Template for comments and secretariat observations:

Date: 2016_03_08	Document: ISO/FDIS 7637- 3	Project:
------------------	----------------------------	----------

ISO/TC22/SC32/WG3 N 2572

Figure 2 – Test set-up for CCC method – DUT Test

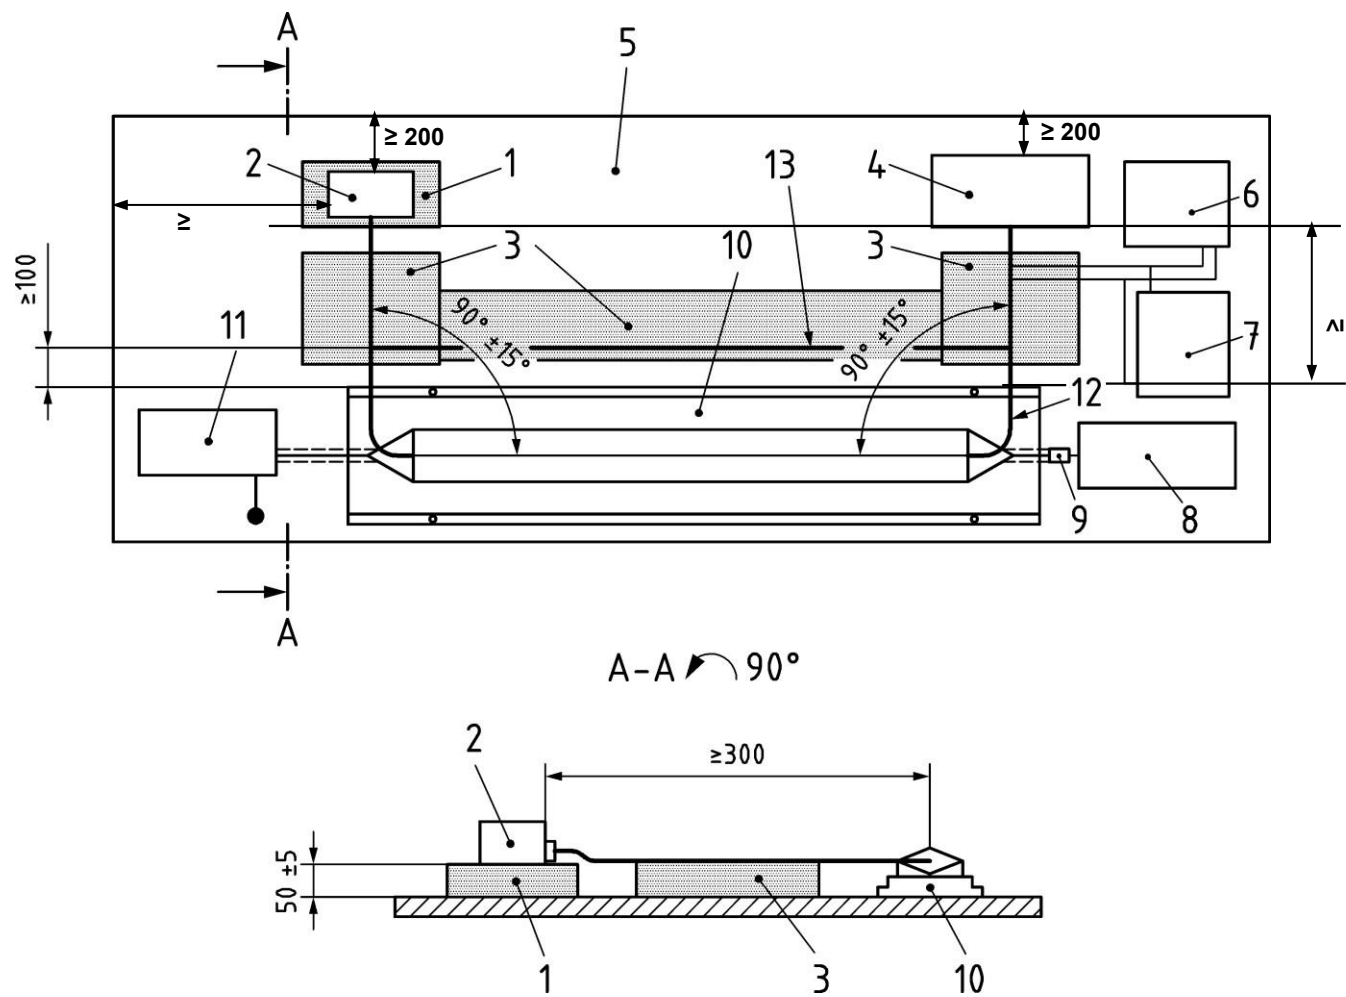
US 4	4.4	3rd paragraph	ed	Paragraph talks about placement of the DUT on an insulator above ground or directly on ground and also attempts to talk about local DUT grounding. The paragraph is confusing. Also, the same information is repeated in sections 4.5.4, 4.4, and 4.74 for the three test methods. Each of those are similar information but wording is different in each one	Clear and concise DUT setup information should only appear in section 4.4 since it is common for all test methods. All redundant statements should be removed. Two changes are proposed. 1) Replace the text in 4.4, 3 rd paragraph with a modified text from section 4.6.4 (para 4 & 5). Specifically: "The DUT shall be placed on a non-conductive, low relative permittivity material ($\epsilon_r \leq 1,4$), at (50 ±5) mm above the ground plane. If the DUT is locally grounded (maximum length of 200 mm), then the DUT's ground supply line shall be connected to the ground plane as defined in the test plan. The DUT has a metal case, it shall not be grounded to the ground plane unless it is intended to simulate the actual vehicle configuration." 2) Delete redundant paragraphs in sections 4.5.4 (para 8 & 9); 4.6.4 (para 4 & 5); and 4.7.4 (para 4 & 5)	Accepted with additional sentences added in 4.5.4, 4.6.4 and 4.7.4 to refer to 4.4 for general condition.

US 6	4.5.3	2 nd paragraph	ed	Use of the phrase "...50 Ω attenuator which is mounted to coupling clamp as shown in Figure 1." is not clear of intent to connect the attenuator to the CCC directly (i.e. no cables)	Propose word change to: "...50 Ω attenuator which is directly connected to the output of the CCC (no intermediate cable connections) as shown in Figure 1."	Accepted
US 7	4.5.4	1 st paragraph	ed	The text: "the test method using the CCC is shown in Figure 2" should be modified because it is talking about the setup not the overall method, which includes test procedures.	Replace text with: "The test setup using the CCC is shown in Figure 2"	Accepted
Fr2	4.5.4	2 nd paragraph	ed	ISO 7637-3 concerns coupling via lines other than supply lines and therefore DUT 12 / 24 V supply lines shall not be included in the CCC.	Replace: "The DUT 12/24 V supply lines (ground and supply) should not be included in the CCC." By : "The DUT 12/24 V supply lines (ground and supply) shall not be included in the CCC."	Not accepted, to technical

Fr3	4.5.4	8 th and 9 th paragraph	ed	These two sentences are not exactly the same than those in paragraph 4.4 (3 and 4 th paragraph) which concerns general test setup conditions conditions for DUT insulation and grounding.	Deleted the two paragraphs.	Accepted see U.S 4
US 8	4.5.4	2 nd paragraph	te	Text states that DUT supply lines (ground and supply) are not to be included in CCC. However ground or supply delivered from DUT to auxiliary equipment (sensors, actuators) is okay to do. The approach is fundamentally flawed because it assumes differences in source/load impedance. The technical rational to preclude primary power/ground to the DUT must also be applied to DUT supplied power to another load (e.g. sensor). The text essentially precludes testing two wire sensors.	Propose the following changes: 1) State that only DUT ground are not to be placed in the CCC 2) Inclusion of an artificial network on the DUT supply to improve coupling efficiency to the supply lead. This has proven to be extremely effective when testing two wire sensors. This change should be applied to all three test methods.	Not accepted

Figure 3b – Set-up for fast transient pulses level adjustment – DCC method

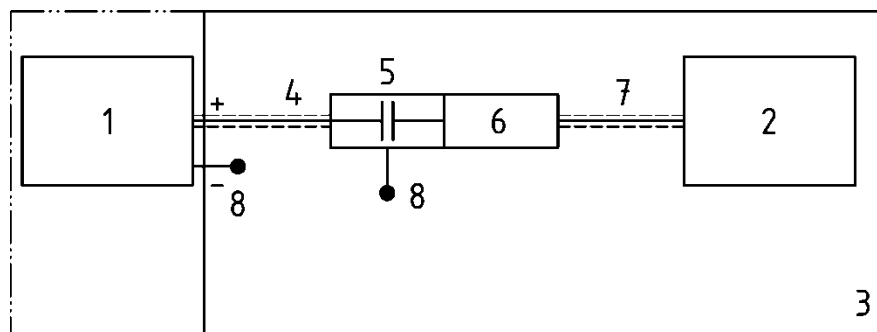
Fr5	4.6.3	Figure 3b	ed	The used of a 1 kΩ to 50 Ω adapter is recommended and not mandatory.	Key 6 : Replace: " 1 kΩ to 50 Ω adapter" by "1 kΩ to 50 Ω adapter (if used) "	Not accepted
US 13	4.6.3	1 st bullet point under paragraph 1	ed	Text states that "The transient pulse level shall be measure using a high impedance passive probe." No parameters are provided regarding the characteristics of this probe. Text should reference ISO 7637-2.	Proposed text change: "The transient pulse level shall be measure using a high impedance passive probe whose characteristics conform with that delineated in ISO 7637-2"	Accepted with addition to reference to clause 5.5 of ISO 7637-2
US 14	4.6.3	Figure 3a	ed	Figure key lists passive probe. Should also include reference to ISO 7637-2	Proposed text change: "6. high impedance passive probe (see ISO 7637-2)"	Accepted see US 13

Figure 4a – Test set-up for DCC method – Slow transients – DUT Test

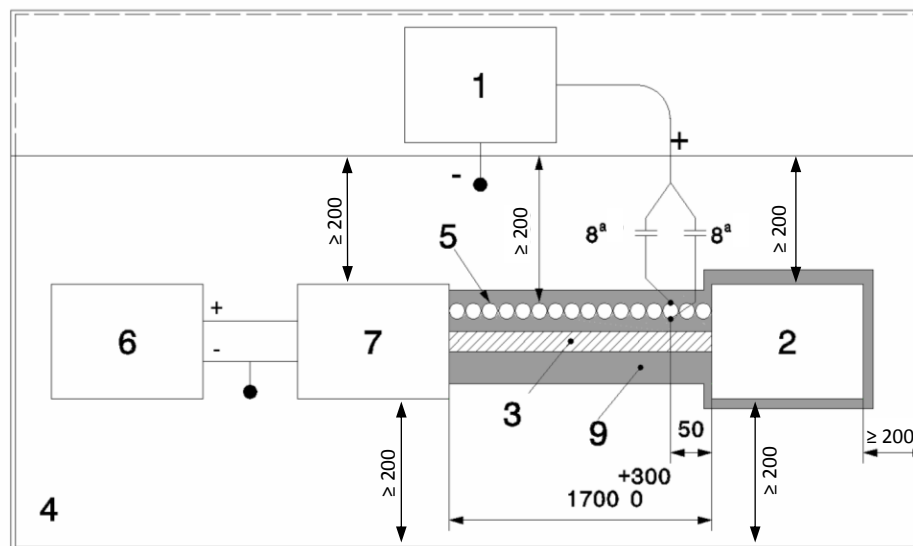
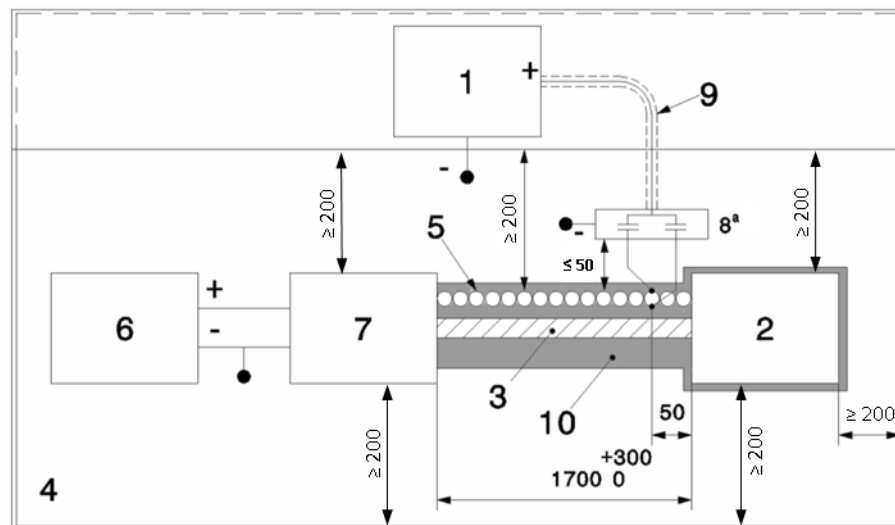
Fr6	4.6.4	4 th and 5 th paragraph	ed	These two sentences are not exactly the same than those in paragraph 4.4 (3 and 4th paragraph) which concerns general test setup conditions for DUT insulation and grounding.	Deleted the two paragraphs.	Accepted see US4
Fr7	4.6.4	Figures 4a, 4b, 5a, 5b	ed	The 50 mm distance should be a maximum distance.	Modify Figures 4a, 4b, 5a, 5b by replacing "50" by " ≤ 50 " for the distance between the DUT and the capacitor connection.	Accepted with 100 instead of 50 mm
Fr8	4.6.4	Figures 4b, 5b	te	The distance between metallic box (8) and DUT I/O line (5) may influence the test result.	Modify Figures 4b, 5b by replacing " ≤ 50 " by : " (50 ± 5) ".	Not accepted but decision to change to ≤ 100 mm
Fr9	4.6.4	Last paragraph	ed	Figures 5a and 5b are examples when figures 4a and 4b aren't. Therefore, it is preferable to have the distance requirements stated in the wording.	Add after last paragraph of 4.6.4 : "The distance between the I/O line injection point and the DUT shall be lower or equal to 50 mm. For fast transient, the distance between the I/O line injection point and the capacitor shielded box shall be (50 ± 5) mm". Delete "Example of" in the title of Figures 5a and 5b.	Accepted with 100 mm Not accepted but decision to change to ≤ 100 mm Accepted for title modification.

Fr10	4.6.4	Figures 4a, 4b, 5a, 5b and paragraph 4.6.4	ed	There is no consistency between the 4 Figures for the distance between I/O line and edge of the ground plane (no requirement in Figure 4a and 4b).	Modify Figures 5a and 5b by replacing "100" by " ≥ 100 " Add in Figures 4a and 4b an arrow with " ≥ 100 " Between I/O line and edge of the ground plane. Add at the end of 4.6.4: "The distance between the I/O line and the edge of the ground plane shall be greater of equal to 100 mm".	Accepted
US 15	4.6.4	paragraph 4 & 5	ed	Information regarding DUT setup is redundant with information provided in 4.4	Delete paragraphs 4 and 5 per US4	Accepted see US 4
US 16	4.6.4	Whole section	ed	There is no mention of including or not including DUT (ground and supply) lines as is delineated in section 4.5.4	Need to have consistency between test methods. However, specific language needs to reconcile with US8.	Withdrawn

US 17	4.6.4	Figure 4a, 4b, 5a, 5b	ed	Figure Key # 8 references paragraph 4.6.1 for capacitor information. Better to reference Table 2 which contains the specific information	Change text for Key # 8 to: "8. high-voltage non polarized leaded capacitor (see Table 2)"	Accepted
US 18	4.6.4	Figure 4a, 4b, 5a, 5b	ed	Dimensions between DUT and edge of ground plan is shown to be >100 mm. This is not consistent with ground plane requirements in 4.3	Update figures to show correct dimensions.	Withdrawn
US 19	4.6.4	Figure 5a, 5b	ed	Superscript by capacitors (a, b). "b" does not exist	Update figure. Replace "8 ^{a,b} " with "8 ^a "	Withdrawn
US 20	4.7.3	1 st paragraph	ed	Figure references are incorrect.	In first sentence, replace "Figures 10 and 11" with "Figures 8 and 9".	Accepted

Figure 7 – Test set-up for ICC method – DUT test

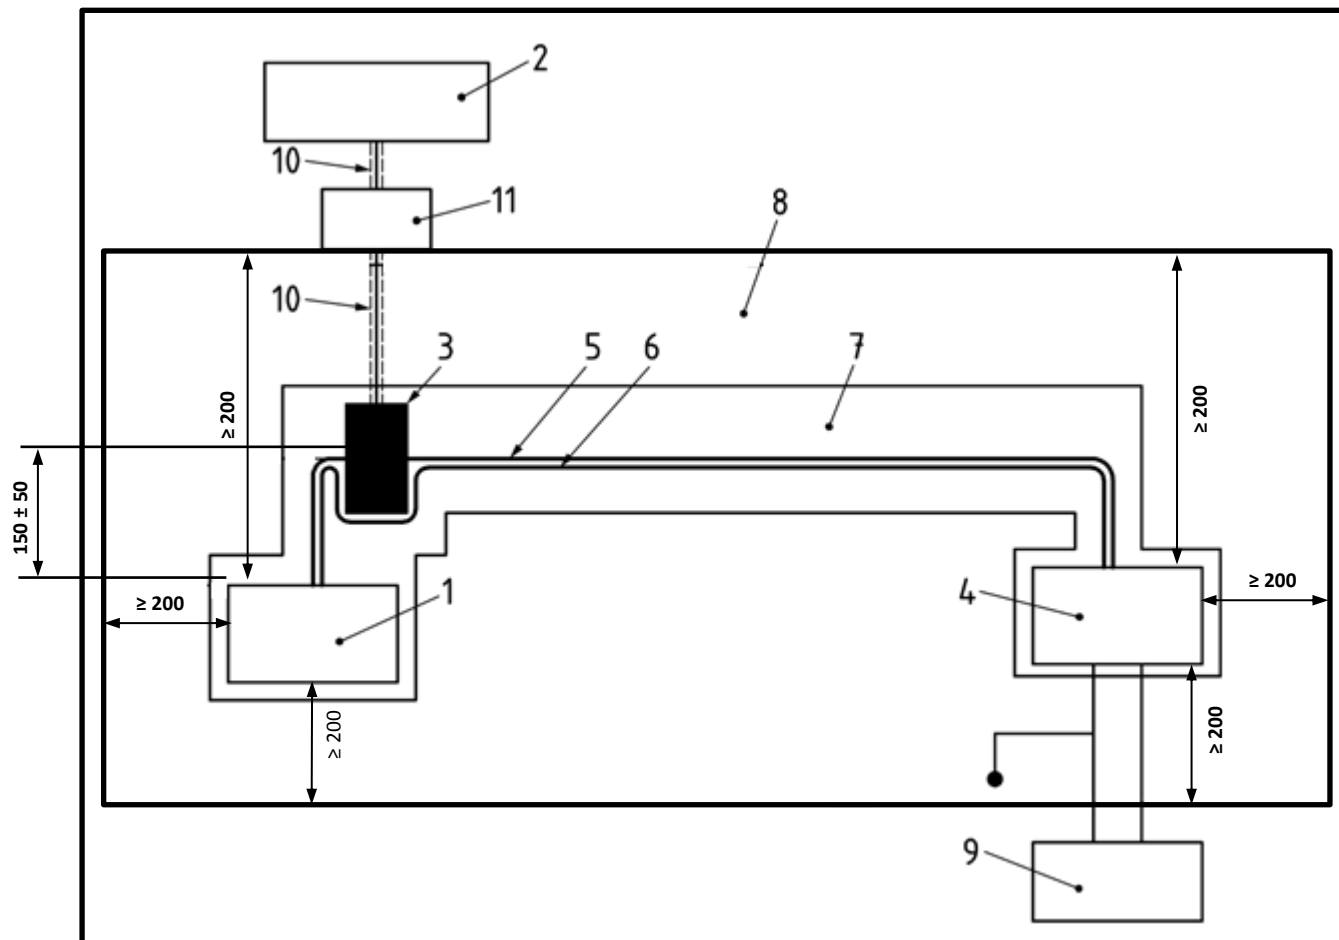
Fr11	4.7.4	2 nd sentence	ed	ISO 7637-3 concerns coupling via lines other than supply lines and therefore DUT 12 / 24 V supply lines shall not be included in the ICC.	<p>Replace: "The DUT 12/24 V power lines (ground and supply) should not be included in the ICC."</p> <p>By :</p> <p>"The DUT 12/24 V power lines (ground and supply) shall not be included in the ICC."</p>	Not accepted
Fr12	4.7.4	4 th and 5 th paragraph	ed	These two sentences are not exactly the same than those in paragraph 4.4 (3 and 4 th paragraph) which concerns general test setup conditions for DUT insulation and grounding.	Deleted the two paragraphs.	Accepted see US 4
Fr13	4.7.4	Figure 7	ed	The wording "Dimensions in millimetres" in missing above the Figure.	Add the wording.	Accepted
US 23	4.7.4	1 st paragraph	te	Text states that DUT supply lines (ground and supply) are not to be included in CCC. However ground or supply delivered from DUT to auxiliary equipment (sensors, actuators) is okay to do. This is the same comments as delineated in section 4.5.4 (CCC method). As stated in US 8, the approach is fundamentally flawed because it assumes differences in source/load impedance.	Propose same approach as US 8	Withdrawn

US 24	4.7.4	2 nd paragraph	te	Text states that ICC test can be performed either as shown in Figure 7 or with a straight harness as implemented in ISO 11452-4. Within ISO 11452-4, the separation distance between DUT and edge of ground plan is to > 500 mm which conflicts with requirements in 4.3.	Delete entire paragraph. Test will be performed in accordance with that illustrated in Figure 7.	Withdrawn
Fr14	5.3.2	Figure 8 and Figure 9	ed	Figure 8 shows a negative pulse when the title is for positive 2a. Figure 9 shows a positive pulse when the title is for negative 2a.	Exchange Figure 8 and Figure 9 (with no change of the Titles).	Accepted
De2	5.3.2	Fig. 8 Fig. 9	ed	Figure and caption do not fit to each other Figure shows positive pulse, caption says negative, and vice versa	Exchange Fig. 8 and 9 without changing the captions	Accepted
US 25	5.3.2	3 rd paragraph	ed	Figures 10 and 11 are referenced. It should be Figures 8 and 9.	Change sentence to: “The transient pulse shapes and parameters are given in Figures 8 and 9.”	Accepted
